No. AS365-52.00.29

ALERT SERVICE BULLETIN

DOORS - Emergency exit
Emergency evacuation labels for helicopters
installed with fixed parts of FLIR system

Corresponds to modification MC90B73

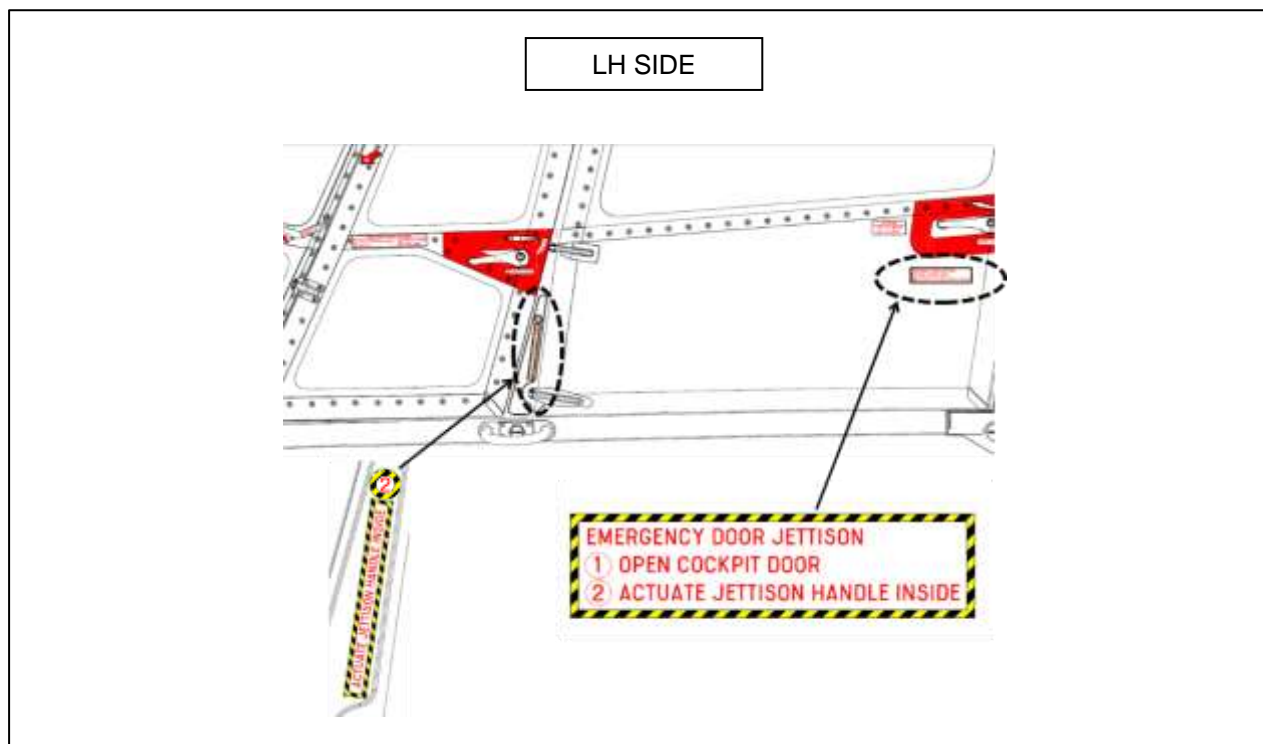
The front passenger door is an emergency exit. It must be possible for rescuers near the helicopter to open the door. When the helicopter is installed with the FLIR system, the upper strut of the FLIR external assembly does not let the front passenger door open. But a rescuer can continue to eject the door with the jettison handles which are installed in the cabin.

The rescuer can operate the jettison handle through the access at the cockpit door.

This ALERT SERVICE BULLETIN installs labels on the external LH and RH side of the helicopter to give instructions to the rescuers on how to operate the jettison handles.

Figure 1

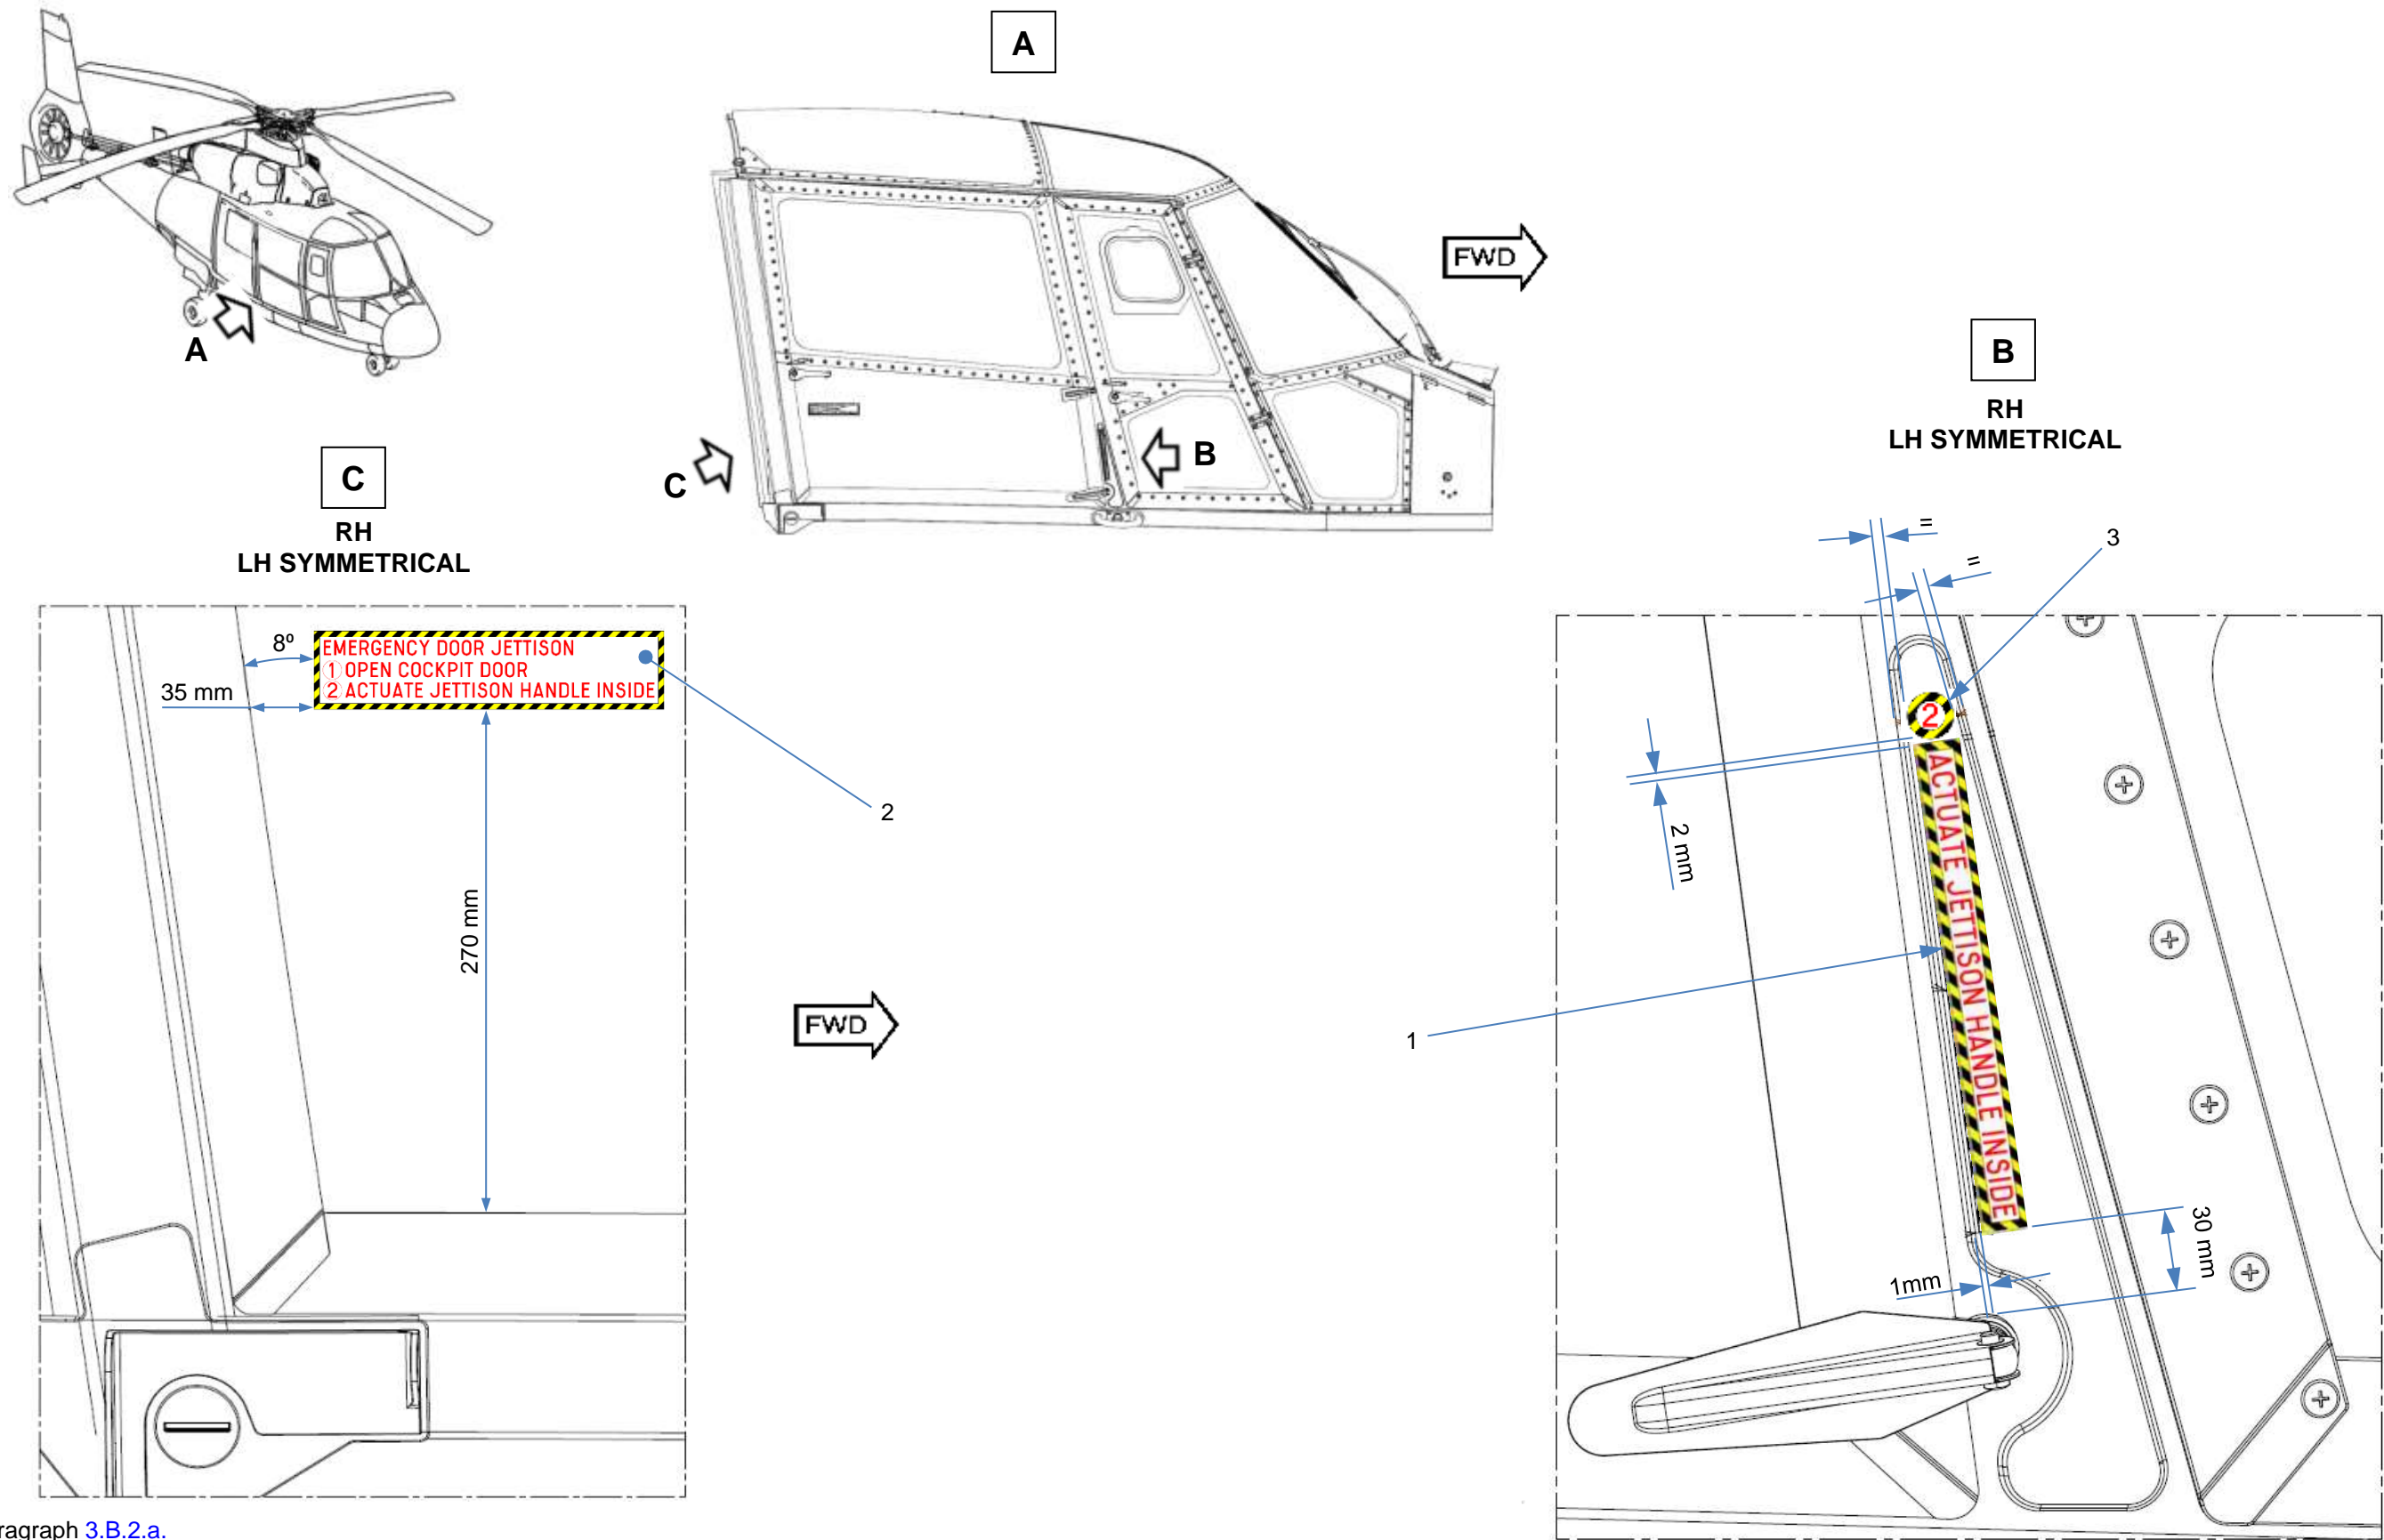
3.B.2.a. Installation of default English labels ([Figure 1](#), DETAILS B and C)

- Refer to Work Card 20-04-07-401 (MTC).
- Install the labels (1), (2) and (3).

Figure 2

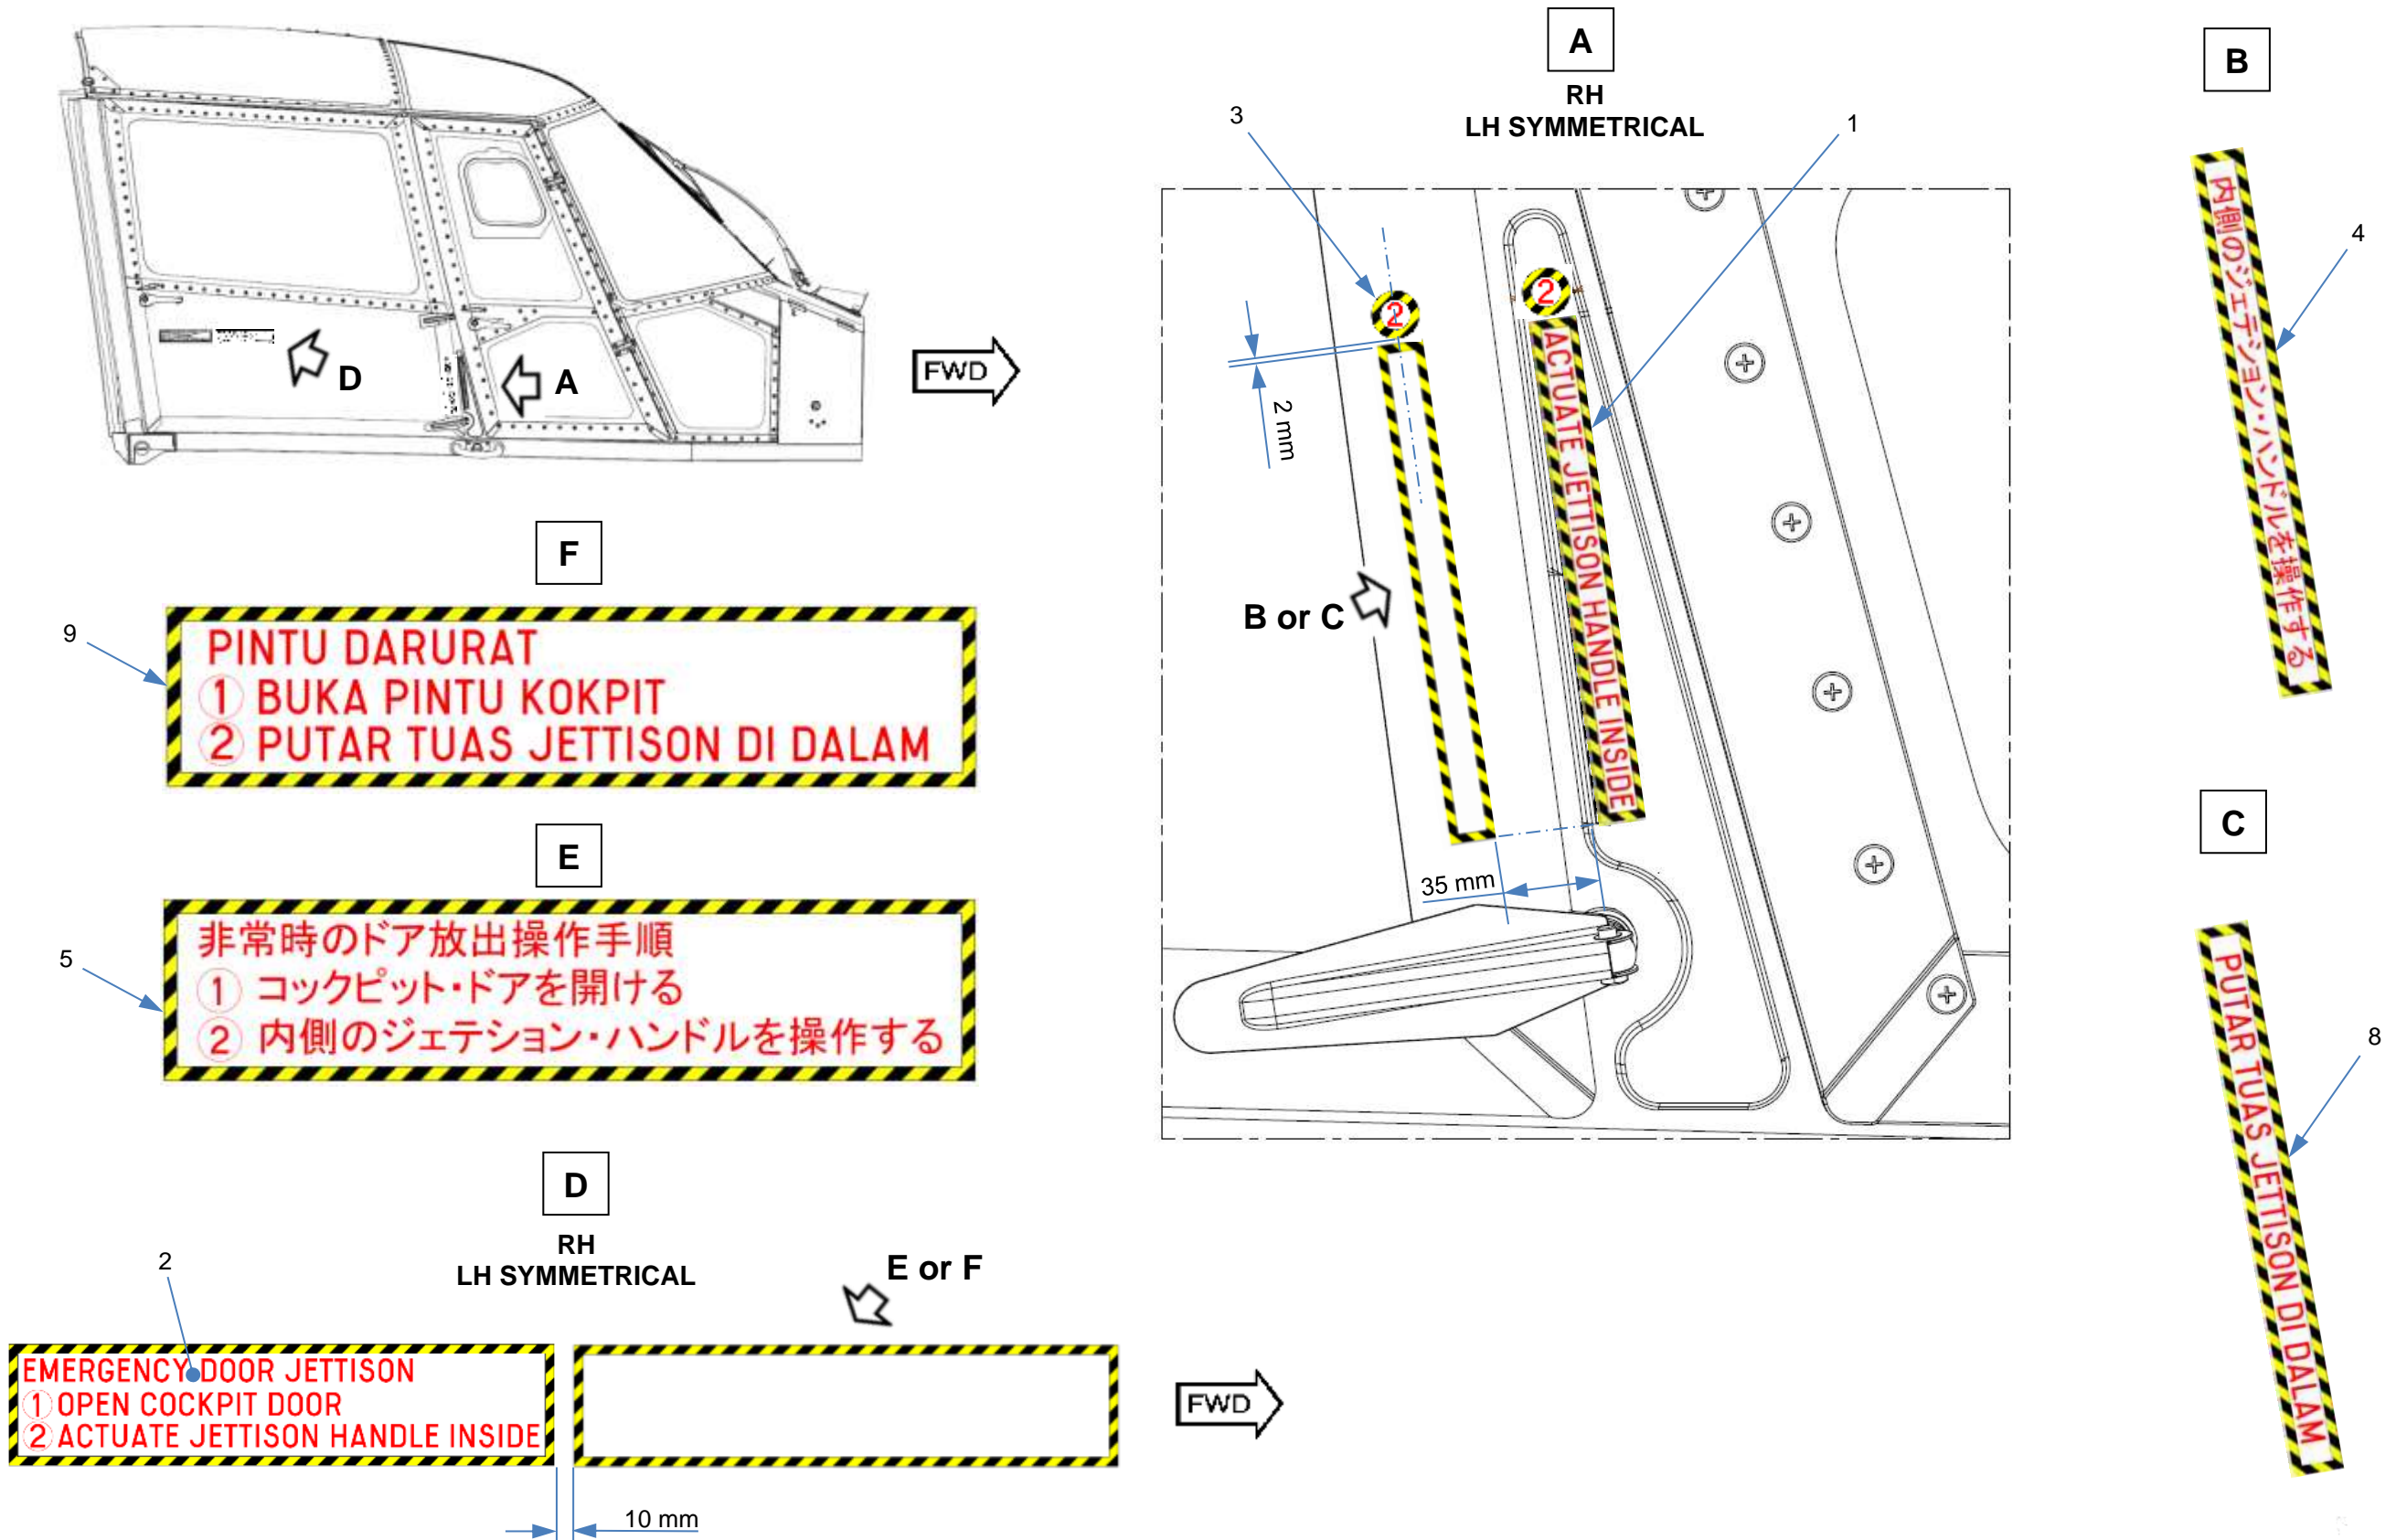
- If Japanese text is required:
 - . Install the label (4) adjacent to the label (1) ([Figure 2](#), DETAILS A and B).
 - . Install the label (5) adjacent to the label (2) ([Figure 2](#), DETAILS D and E).
 - . Install the label (3) above the label (4) ([Figure 2](#), DETAILS A and B).
- If Indonesian text is required:
 - . Install the label (8) adjacent to the label (1) ([Figure 2](#), DETAILS A and C).
 - . Install the label (9) adjacent to the label (2) ([Figure 2](#), DETAILS D and F).
 - . Install the label (3) above the label (8) ([Figure 2](#), DETAILS A and C).
- If Spanish text is required:
 - . Install the label (6) adjacent to the label (1) ([Figure 3](#), DETAIL A).
 - . Install the label (7) adjacent to the label (2) ([Figure 3](#), DETAIL B).
 - . Install the label (3) above the label (6) ([Figure 3](#), DETAIL A).
